Interim Reclamation and Stormwater Inspection

Operator: PADCO LLC - 24500

Location ID: 317037

Inspection Photos
Location Name: Fassler 1
Location ID: 317037

Photo 7. See comments in Photo 6.

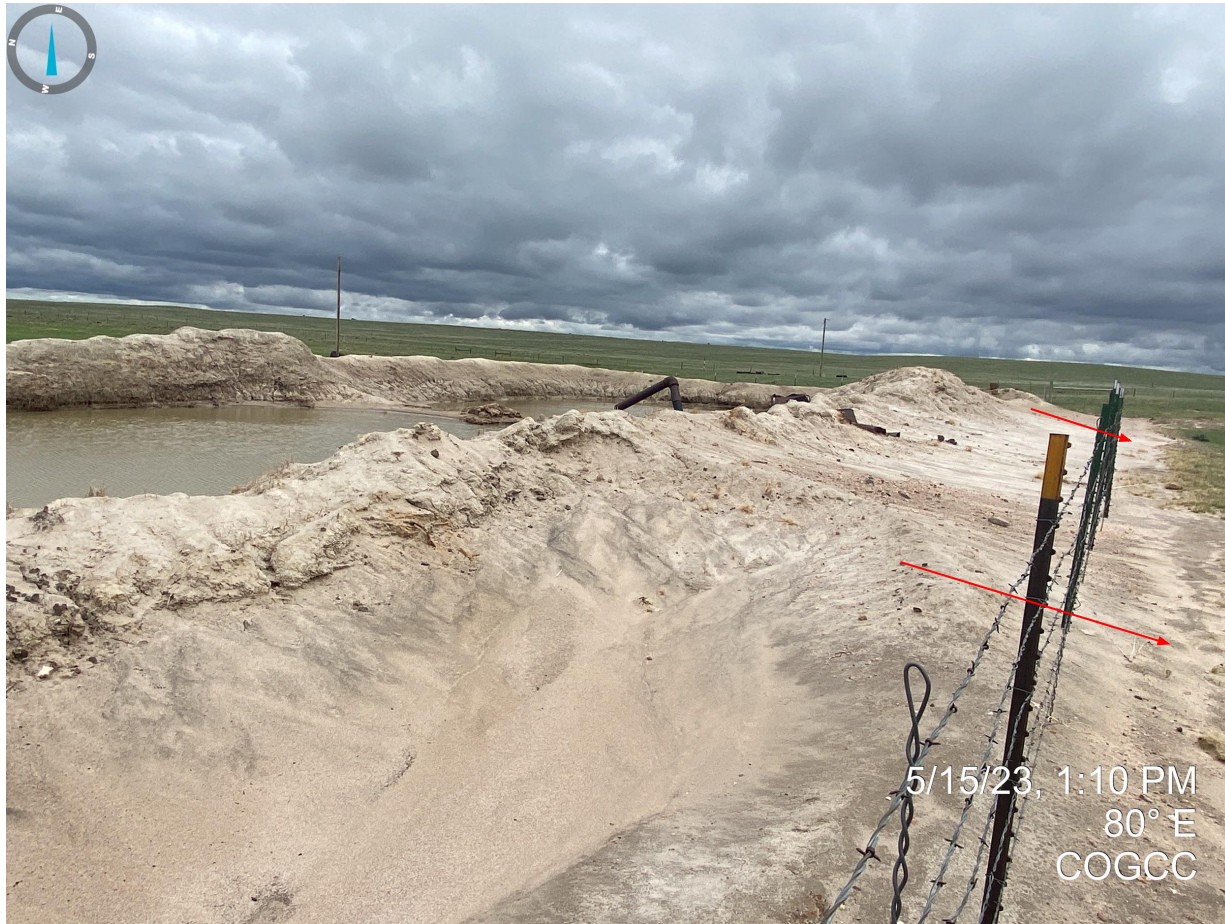
Photo 6. Pit berms/walls do not appear to be properly stabilized as unconsolidated material and rill erosion was evident throughout. As a result, sediment laden stormwater exited outside of the fenced areas onto adjacent lands. More robust stormwater BMPs will need to be implemented to stabilize the material.
